Schematic	Rocket_New	Update Date	2025-02-23
		Create Date	2024-11-24
Page	ROCKET_PCB	Part Number	JLCPCB-001
Drawn	Omar TPX	Rocket_PC_Last	
Reviewed	None		
		VER	SIZE	PAGE 1 OF 1
EasyEDA		V0.1	A2	Omartpx.site

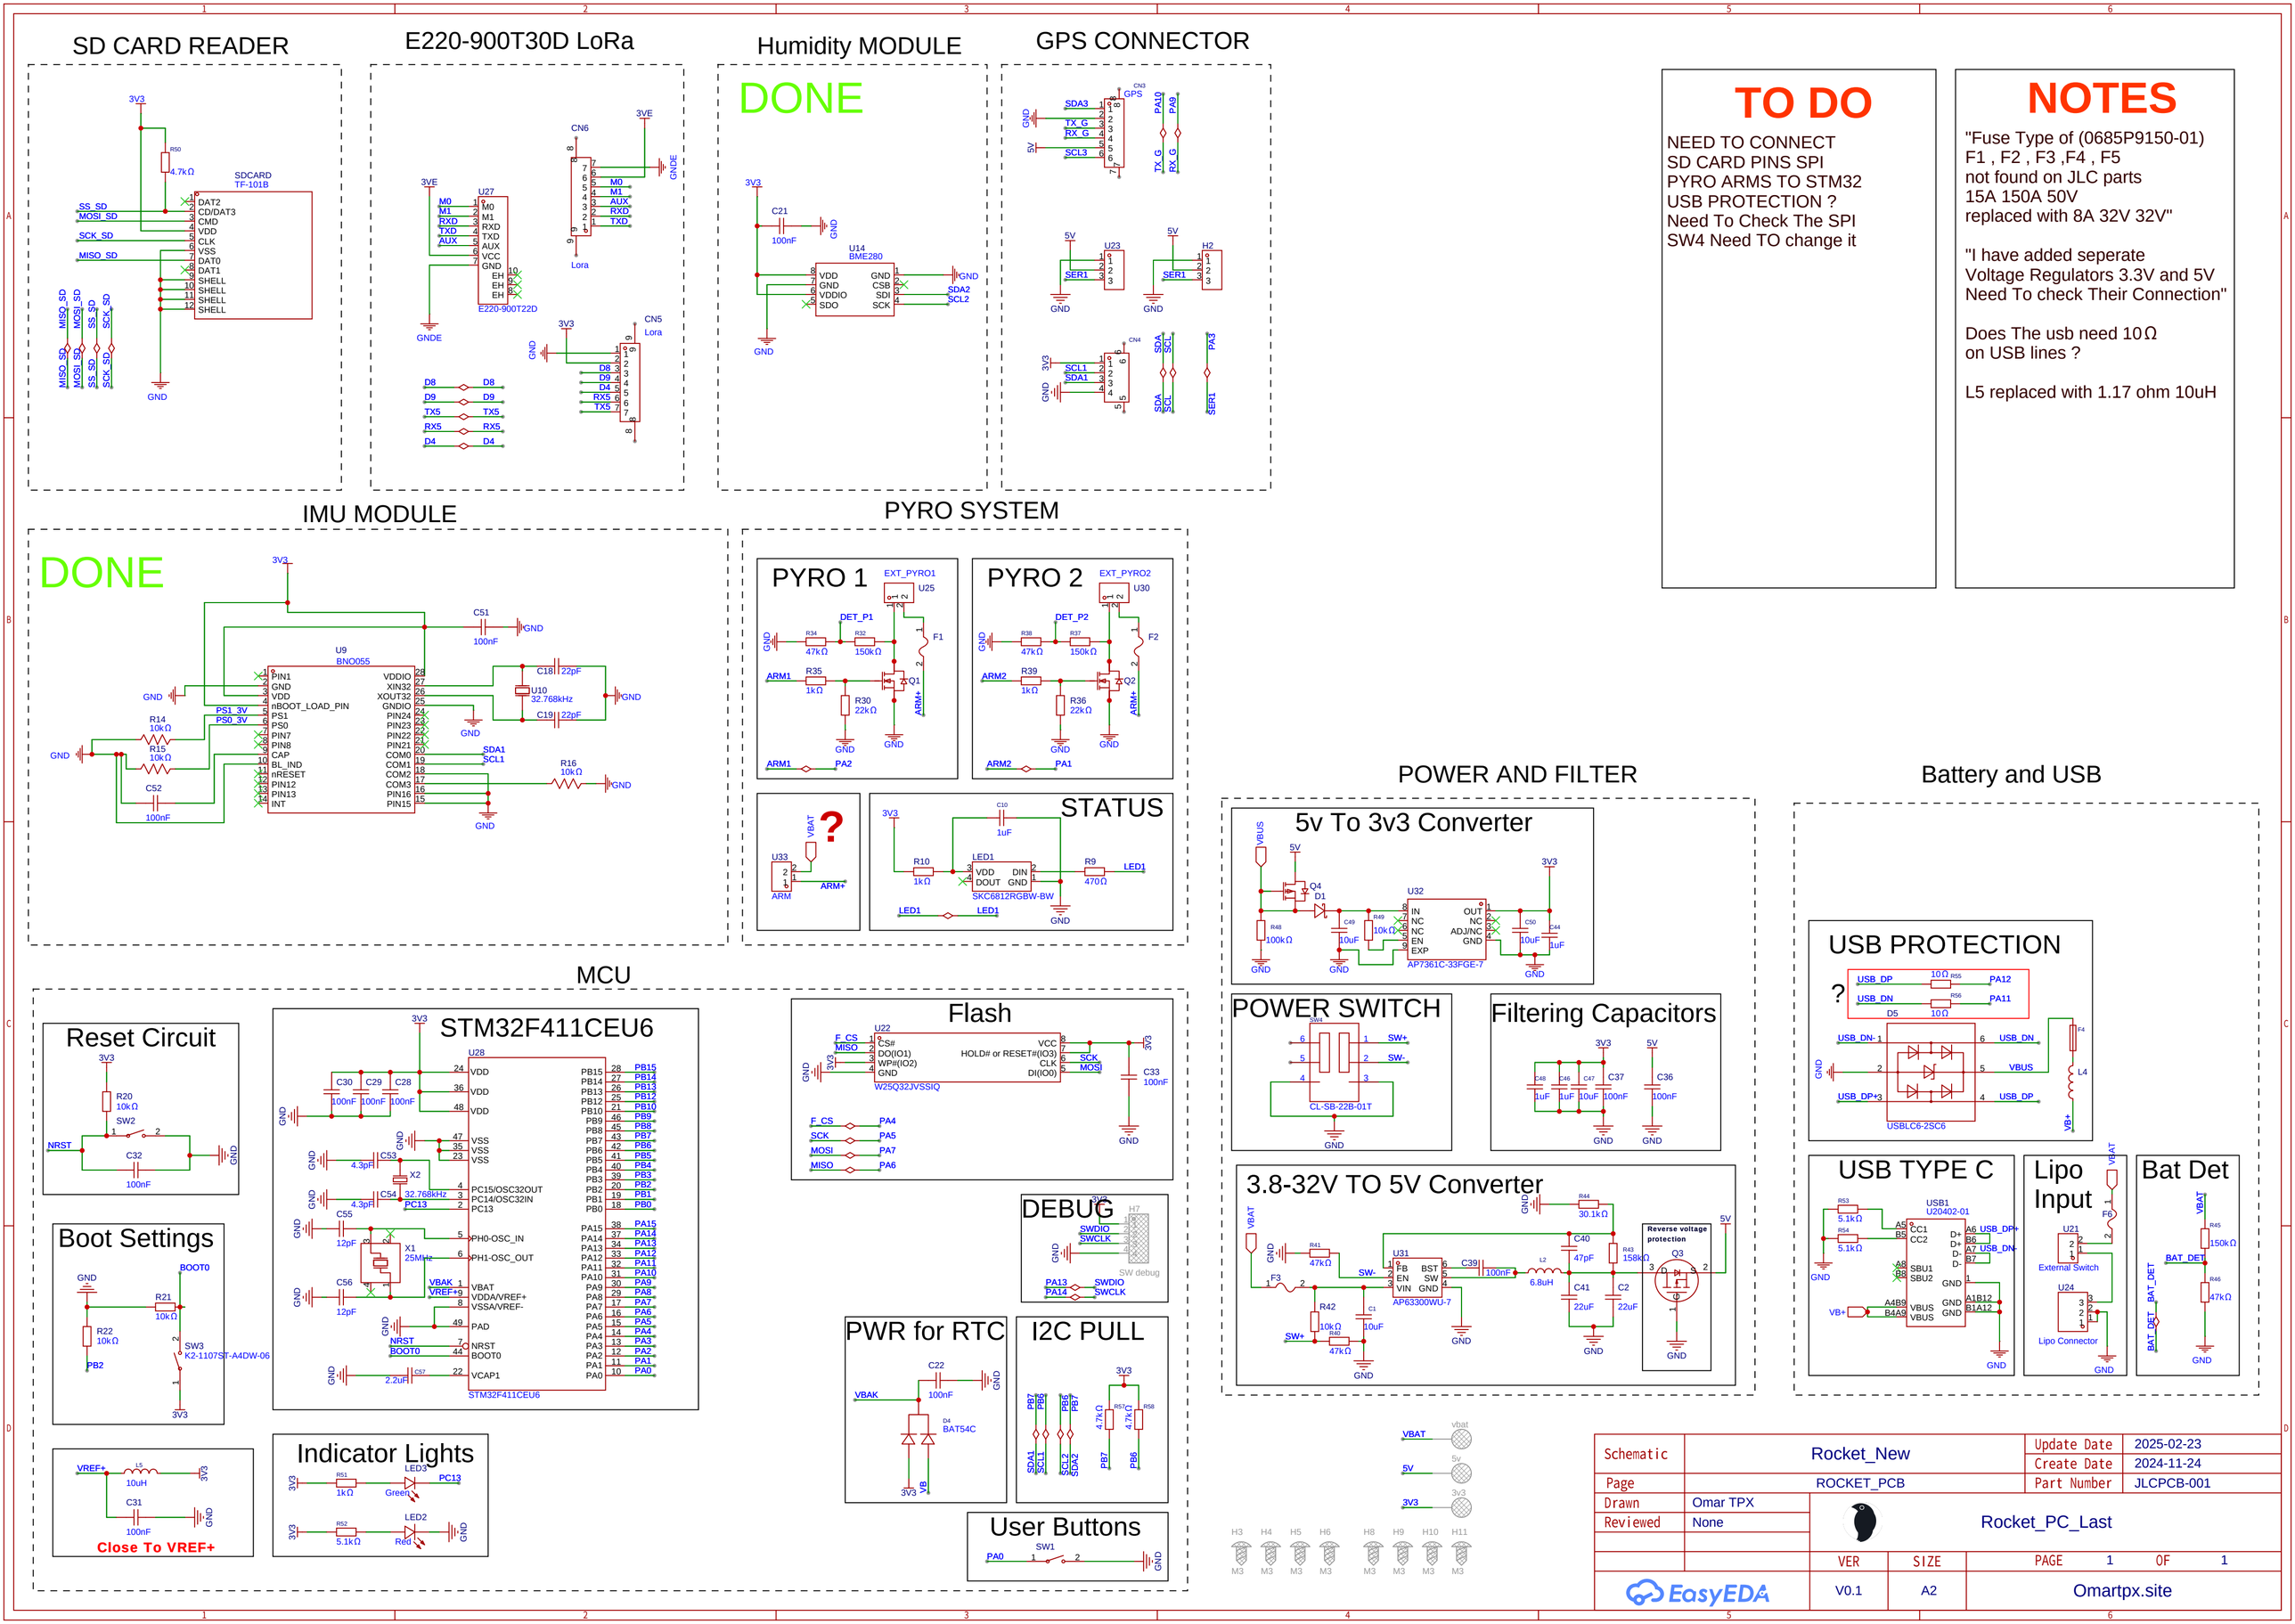
NEED TO CONNECT
SD CARD PINS SPI
PYRO ARMS TO STM32
USB PROTECTION ?
Need To Check The SPI
SW4 Need TO change it

"Fuse Type of (0685P9150-01)
F1 , F2 , F3 ,F4 , F5
not found on JLC parts
15A 150A 50V
replaced with 8A 32V 32V"

"I have added seperate
Voltage Regulators 3.3V and 5V
Need To check Their Connection"

Does The usb need 10Ω
on USB lines ?

L5 replaced with 1.17 ohm 10uH
